SSD 13_5816 - Stage 3A Redevelopment of Lismore Base Hospital Response to Submissions

Health Infrastructure (HI) has reviewed the submissions received during the exhibition of the above application. In response to these submissions, HI has made some minor changes to the design of the proposal and has set out below our comments on the issues raised. The following revised drawings are also submitted in response to the submissions

ATTACHMENT 1
Amended architectural & landscape plans

Drawing title
SITE PLAN

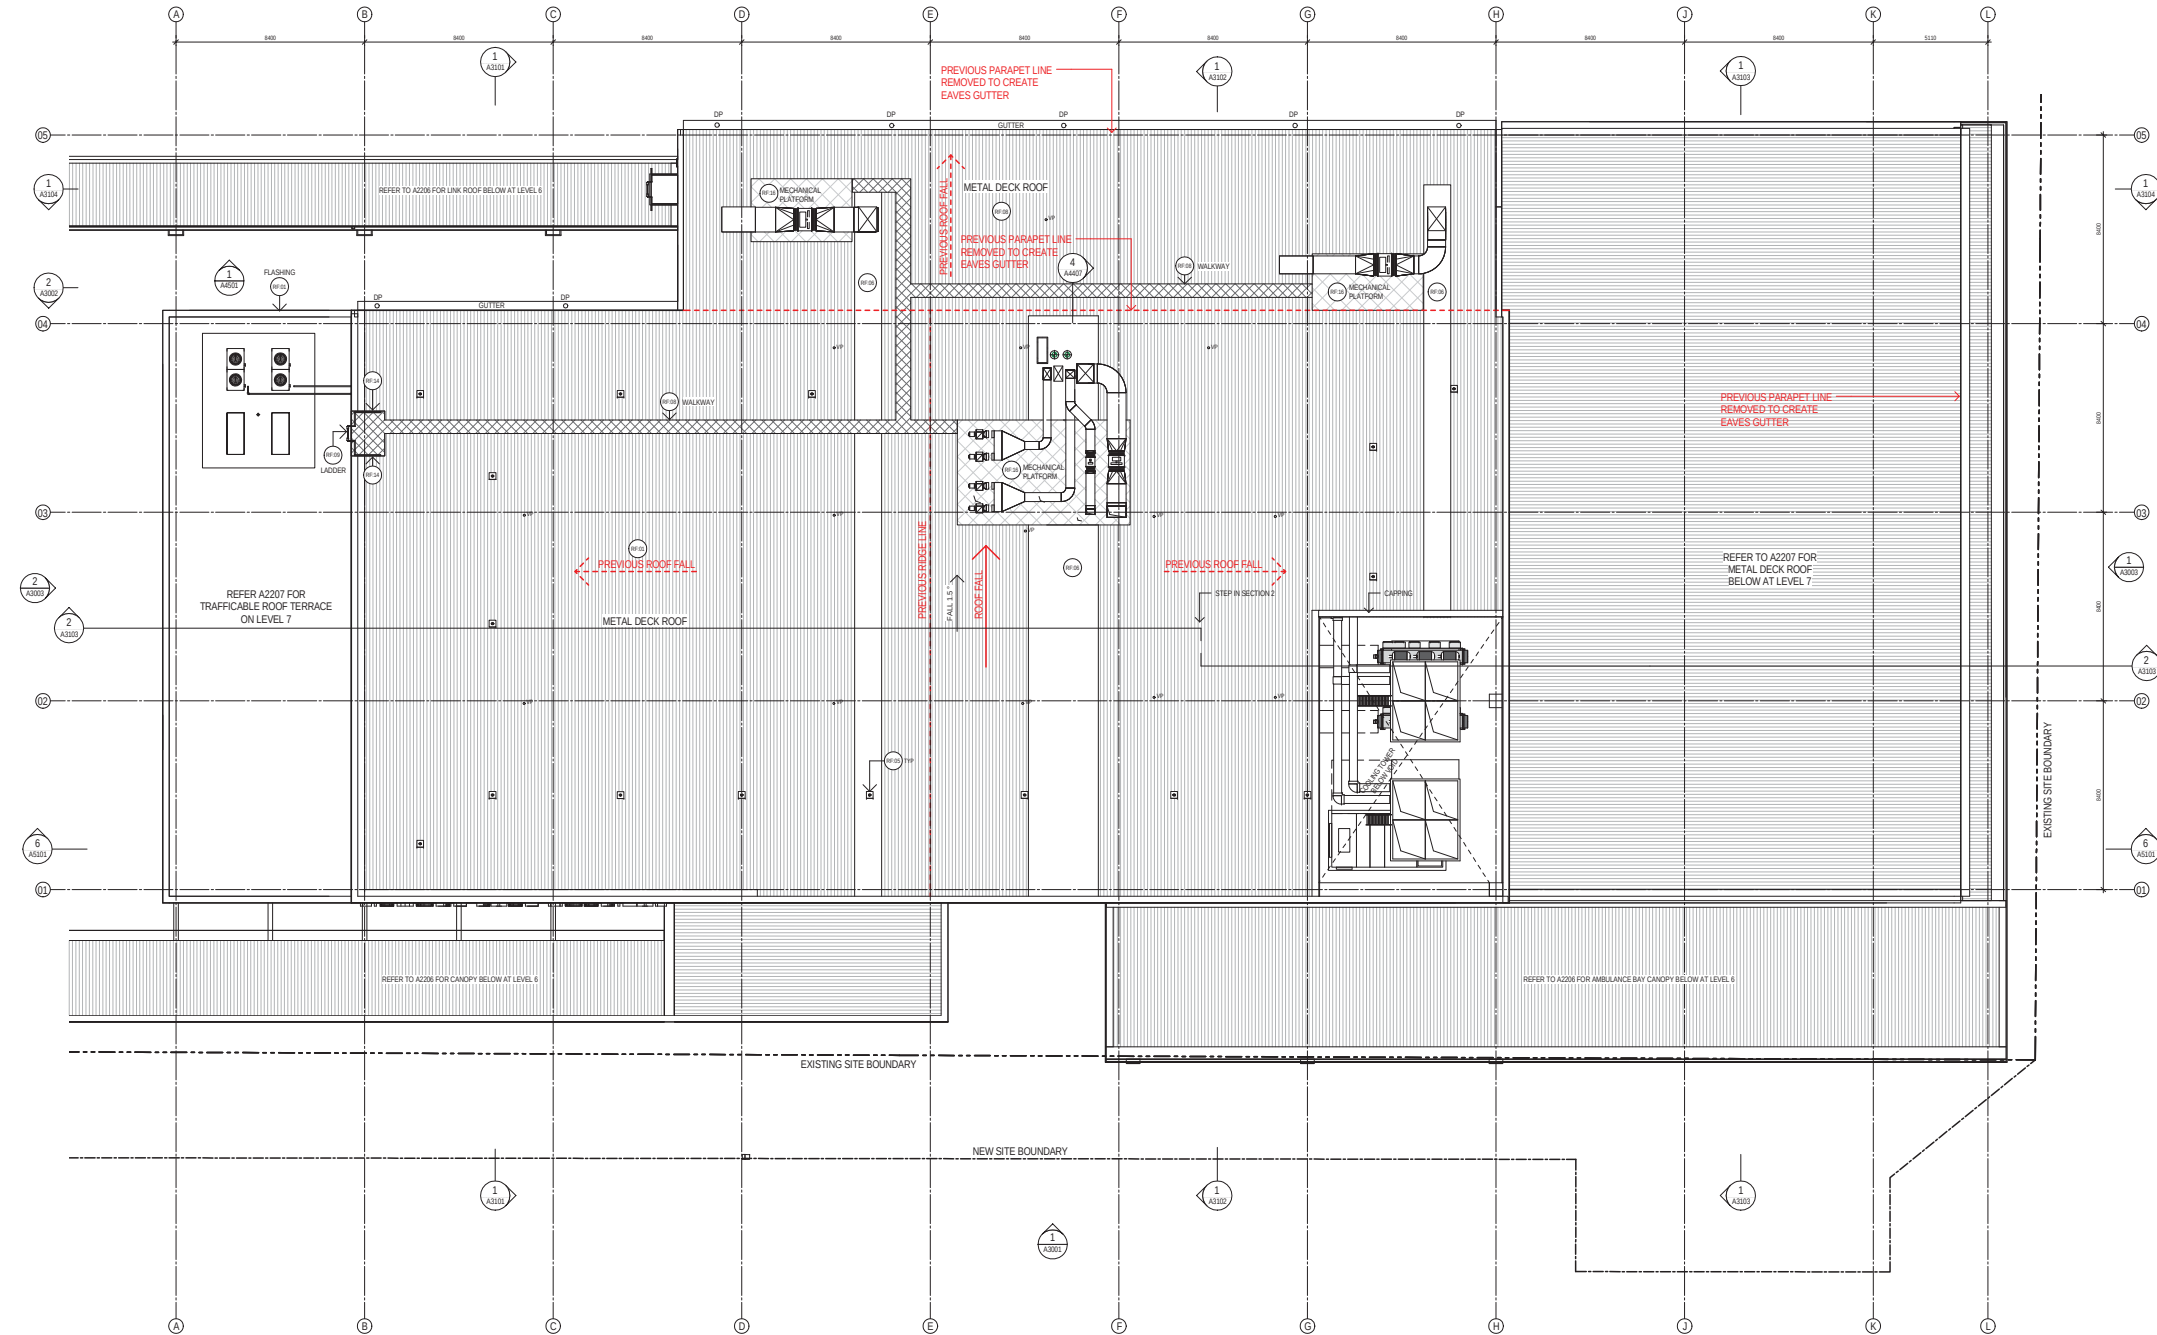
Parking availability – contribution to Council for Licence Plate Recognition technology.	Council has requested that consideration be given to providing funds to Council for the acquisition of Licence Plate Recognition technology to assist with parking enforcement in the Lismore area. The Lismore Base Hospital redevelopment project is being undertaken as a jointly funded health service infrastructure investment initiative under the Health and Hospitals Fund Program, with contributions from both the Australian Government and the NSW State Government. The purpose of the funding is to deliver improved health facilities in accordance with an agreed scope and it is not considered appropriate that health funding is reallocated away from health services to assist LCC with parking enforcement initiatives."
	Boundary Adjustments	Council has requested that the indicative proposed new boundary line be slightly adjusted. HI accepts this position and the new boundary alignment is reflected on the attached drawing A1002 Rev. F Site Plan.

Drawing title: GA - LEVEL 08
Checked: AJ HA
Approved: AJ HA
Scale: 1:100
Sheet size: B1
50mm on original

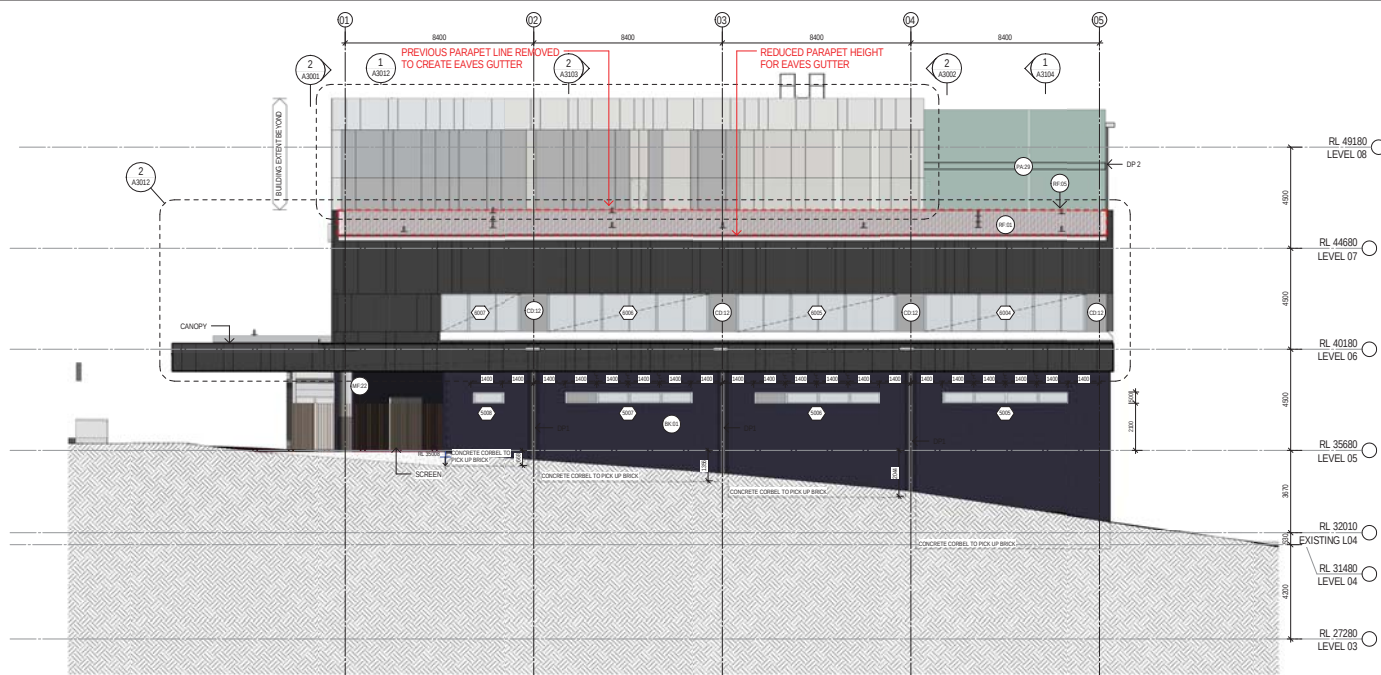
In addition to the design modifications set out in the responses above, the proposed roof has been amended to eliminate box gutters, significantly reducing the maintenance for the hospital. The main roof now falls to the north to ensure no box gutters behind parapets are required. Due to this change the parapet on the northern façade has been pulled down, as has the eastern façade. These changes are shown in red on the amended architectural plans attached:

WOODS BAGOT
120179
A3003
K

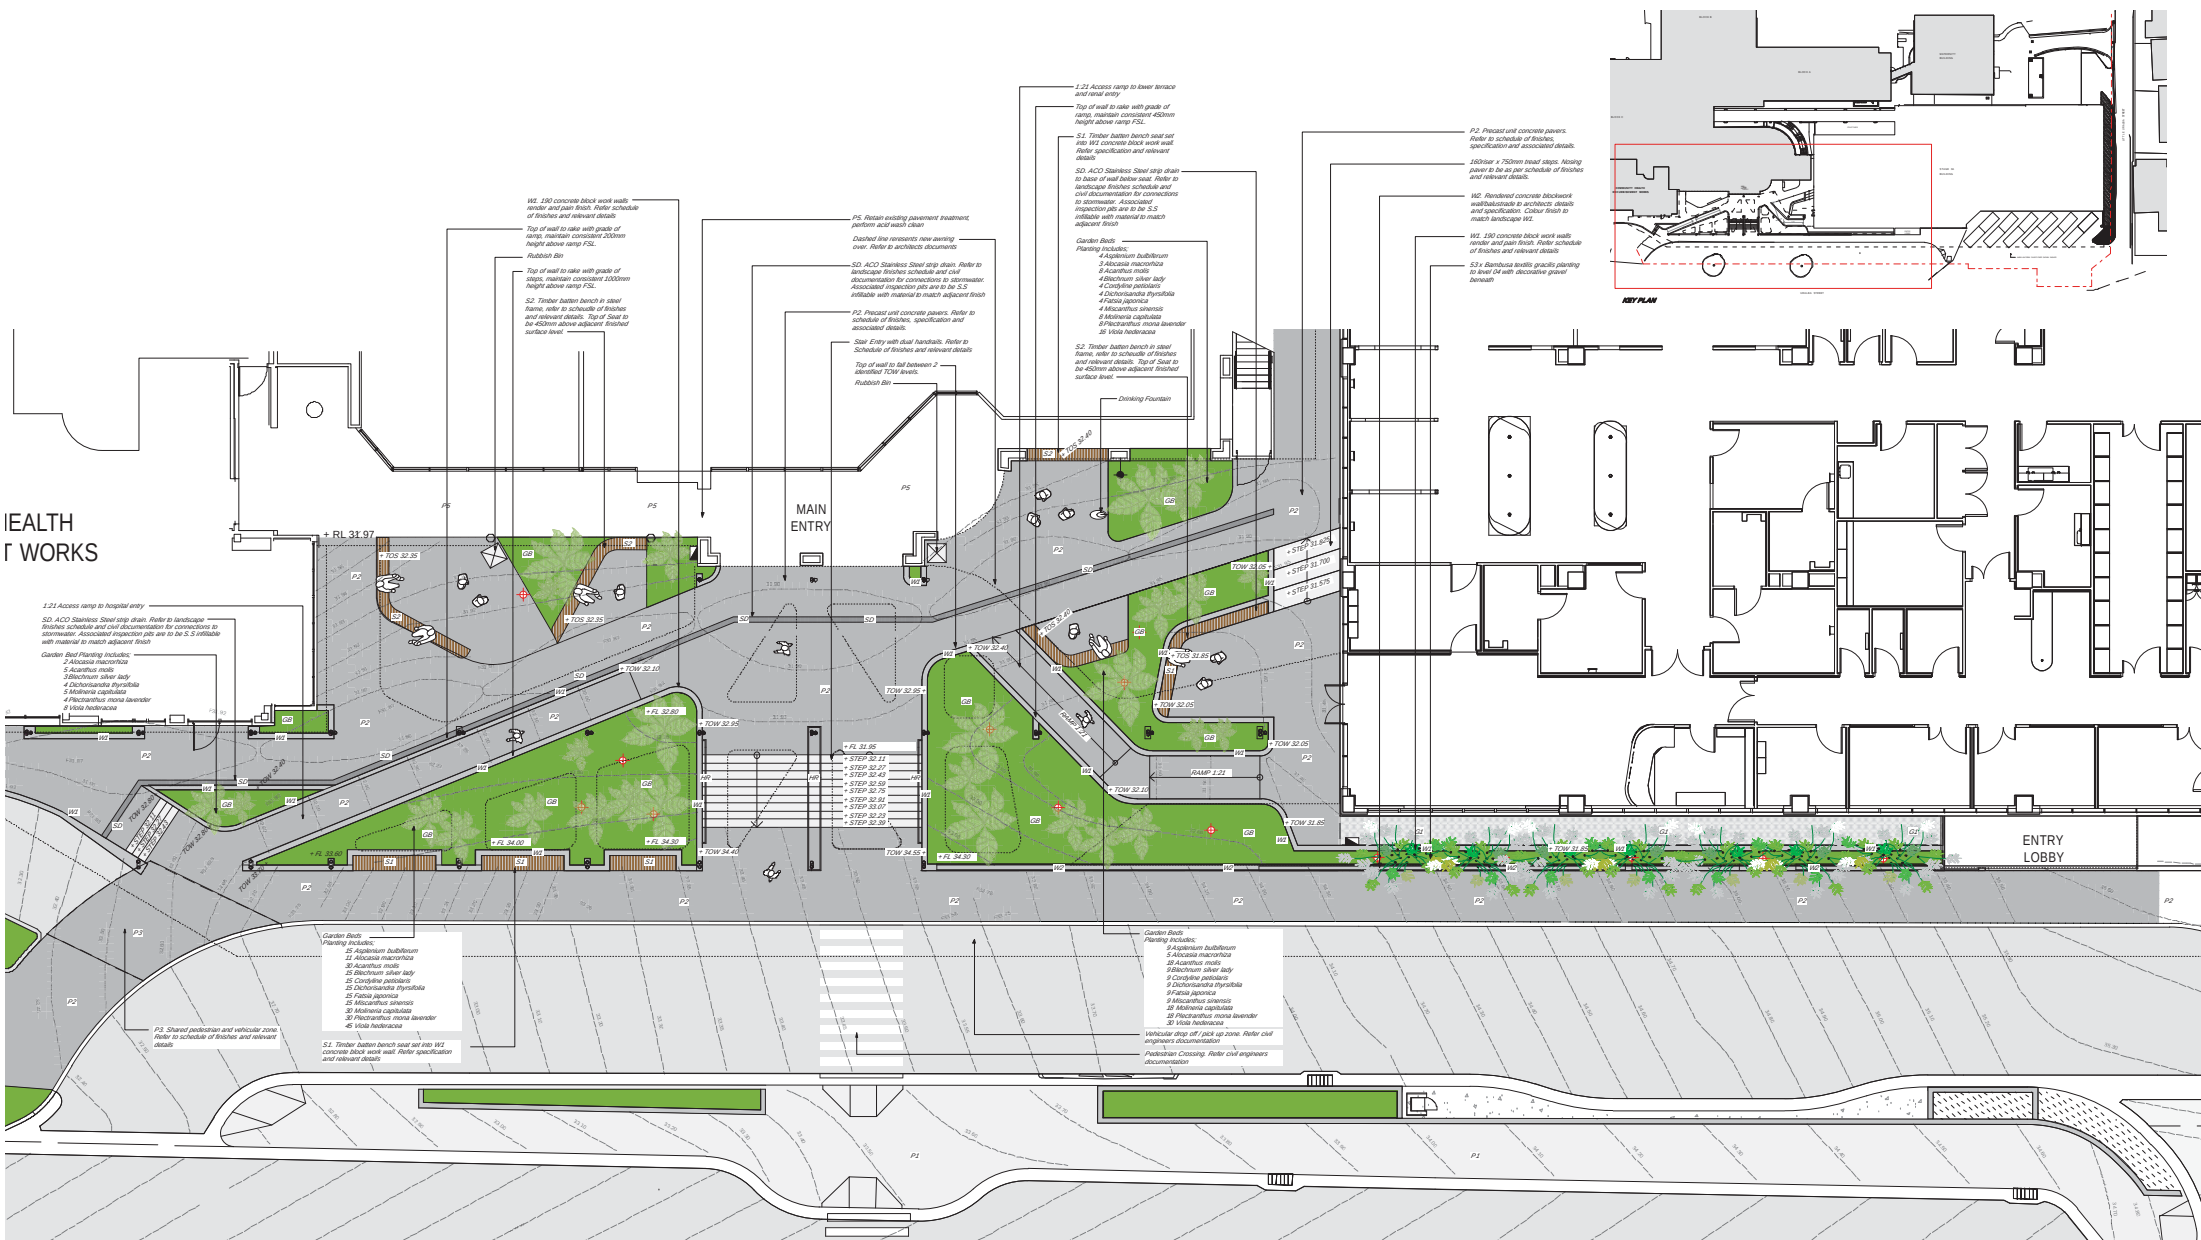
AREA OF FACADE REDUCED
FOR EAVES GUTTER
